Meeting Summary
INTERDISCIPLINARY WORK GROUP
Wednesday July 17, 2024
MS Teams

Peterson gave the purpose of the meeting (IDT support of the Riparian proposal). During the prior meeting, proponents for other proposals were allowed to field questions during IDT discussion, however proponents for this proposal were not available. The IDT deferred final discussion; this is that opportunity and Peterson noted that Bair would likely be able to respond to most questions. Peterson gave a brief overview of the proposal, then opened the floor for discussion.

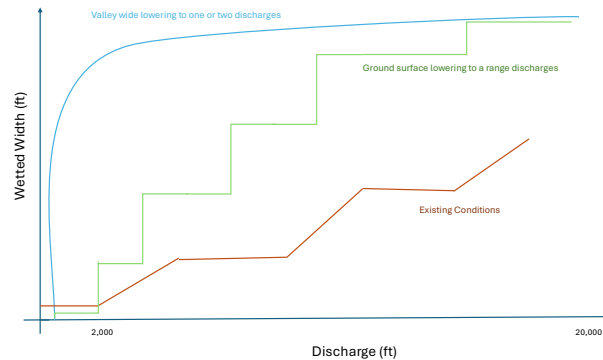
- Bair presented conceptual graphs of wetted width as a function of site design and related this to anticipated vegetation diversity

- Peterson - Given the graphs John showed, perhaps the hypothesis could be stated to something like “Floodplain elevation diversity directly relates to the floodplain vegetation diversity”; then if within-site sampling covers a range of elevation diversity, perhaps the analysis could validly compare veg diversity to elevation diversity.

- Bair said it was possible to restate the hypothesis but made the point that all these factors are components of hydraulic geometry and are interrelated.
